## **Staff Report to the Board of Trustees**

### **Weber Grill Restaurant – Downtown Orland Park Parcel H**

**Project:** 2025-0574 Weber Grill Restaurant – Downtown Orland Park Parcel H

## SITE PLAN

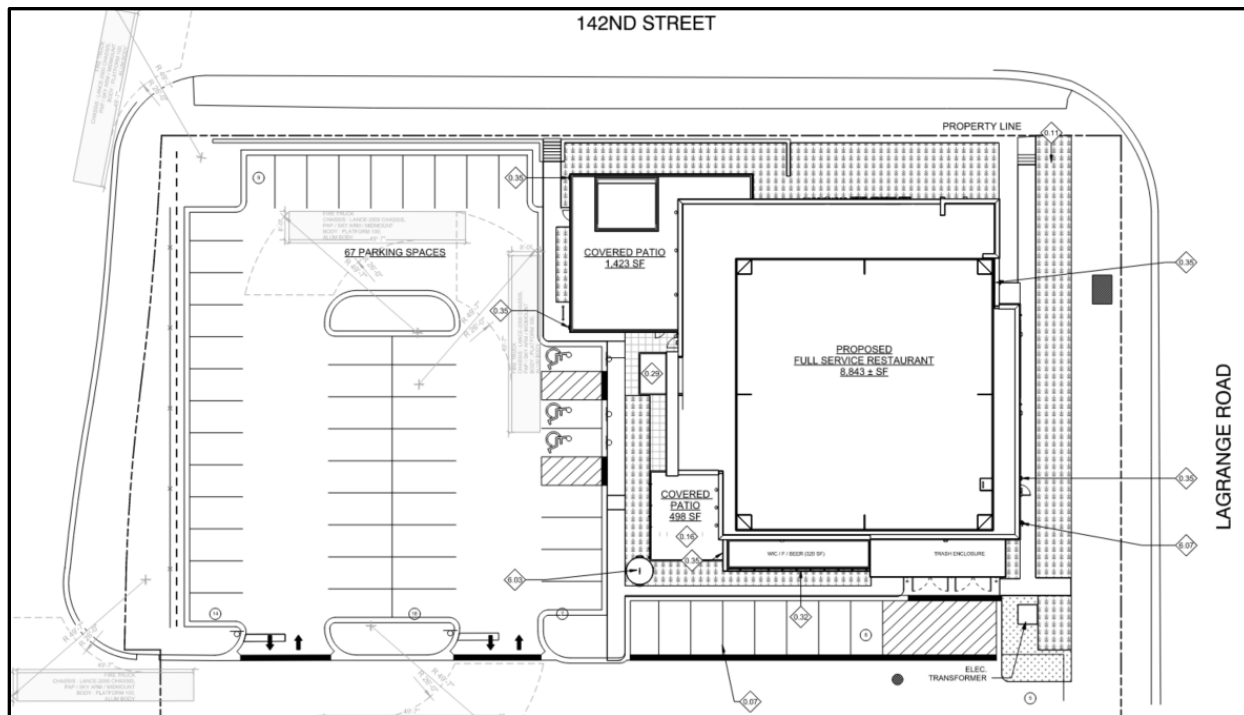
Parcel H shares an existing shared driveway with UCMC located on Jefferson Avenue. Pedestrian access is provided from 142nd Street to the north and directly from LaGrange Road to the east. Internal sidewalks are proposed around the entire parcel, except for the vehicle entrance on Jefferson Avenue. The parking lot for Parcel H is designed as an extension of the existing UCMC parking lot. All proposed setbacks follow Village requirements. A modification allowing parking within the setback area between the building façade and the street (Section 6-212.E.2) was previously granted for this parcel as part of the overall concept plan approval (Ord. No. 5927).

The Land Development Code (LDC) requires restaurants to provide one parking space per 100 square feet of tenant space. Based on the proposed 8,843-square-foot Weber Grill, 88 parking spaces are required; however, only 67 spaces are provided on site. Within the VCD District, shared parking is permitted and encouraged. Additional parking for the restaurant is available in the UCMC lot located south of the building and in the parking garage on Parcel F. The Walker Consultants parking study, last revised July 16, 2024, supporting the Downtown Orland Park Concept Plan, identified shared parking arrangements for the overall planned development and demonstrates that enough capacity exists to accommodate Weber Grill at this location.
